Title: 23161 TN11 Response to LHA Comment Residential 1st Issue

Date: June 2025

1.0 Introduction

- 1.1 Jubb has been commissioned by Hallam Land Management to provide transport and highways advice in relation to a proposed residential led development on land to the west of Buntingford and within the district of East Hertfordshire.

Figure 4.1 –Proposal for bus route diversion (extracted from Figure 4.1 of the latest PTU TN)

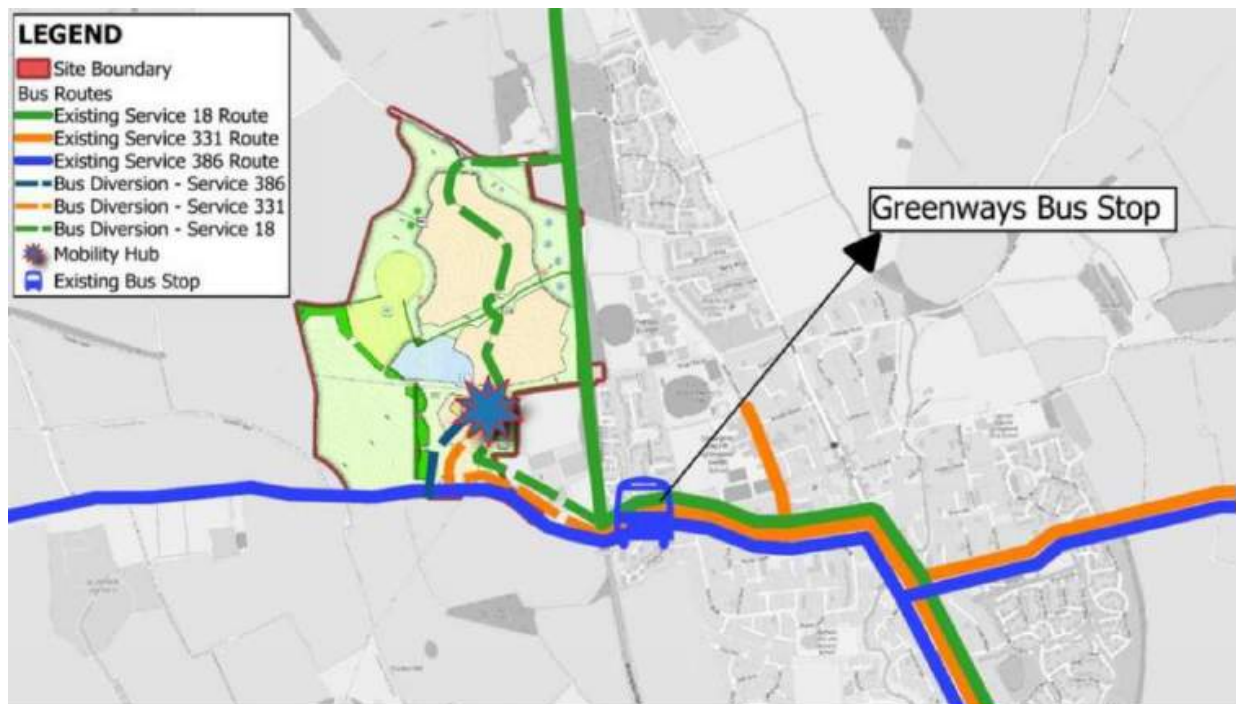
The site's isolated location on the outskirts of Buntingford (extending into a rural area), in of itself a settlement that is noted to be poorly connected to neighbouring towns necessitates a robust approach to promoting sustainable travel and moreover examining in detail the impacts of vehicular trips, the latter being especially important in a heavily trafficked area with known congestion hotspots. The map below indicates traffic sensitive roads and congestion hotspots in the locality:

The Highway Authority must therefore conclude that the site is likely to be heavily reliant on the use of the private car and therefore contrary for Paragraphs 108 and 109 of the National Planning Policy Guidance.

- 4.8 As set out in **Section 2** a TN (**Appendix D**) has been issued to the PTU that sets out a strategy for connection directly into the site, which is based on a small local diversion of the existing services of 18, 331, and 386 (now 37) as summarised in **Figure 4.1** below which has been extracted from Figure 4.1 of the latest PTU TN. Following issue of this document a meeting was set up with the PTU on the 3rd October 2024 with minutes included as **Appendix M**.
- 4.9 During the meeting it was confirmed that the broad strategy as outlined in **Figure 4.1** below, which will provide direct connection into the site, was appropriate.

- 4.15 The strategy as discussed above, which has been developed in consultation with the PTU, would provide high quality bus access and therefore is considered to address the comments as raised by the LHA in this regard. In addition, it is also understood that a financial contribution has also been agreed to enhance the existing 18 service as part of the proposals for Land to the East of the A10 Buntingford (Planning Reference 3/23/1447/OUT), which will also, given that service 18 is proposed to route through the site, further complement this already high quality public transport strategy.

Figure 4.2 – Proposed Buntingford High Street (Phase 2) scheme as set out on Hertfordshire County Council web site

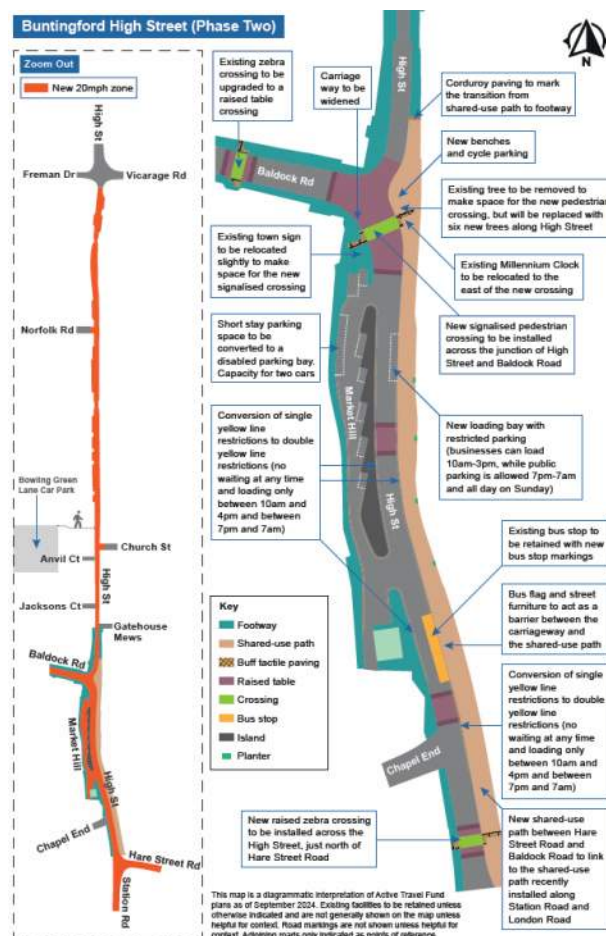
Figures 5.6 to 5.8 detail the proposed mitigation for pedestrians and cyclists on Baldock Road in the direction of Buntingford town centre. It is noted that whilst cyclists have some benefit in terms of a LTN 1/20 style cycle route from the main site access to the Baldock Road/A10 junction, cyclists must join the main road east of the junction to route towards the town centre.

- 4.28 As set out in **Section 3** a drawing has been provided showing an active travel corridor (i.e. shared footway / cycleway) on the eastern side of the A10 on Baldock Road. This corridor will provide high quality access into the centre of Buntingford and would also provide an ideal gateway to the LHA's own proposed improvements on Buntingford High Street as set out in the extract included as included as **Figure 4.2** below.
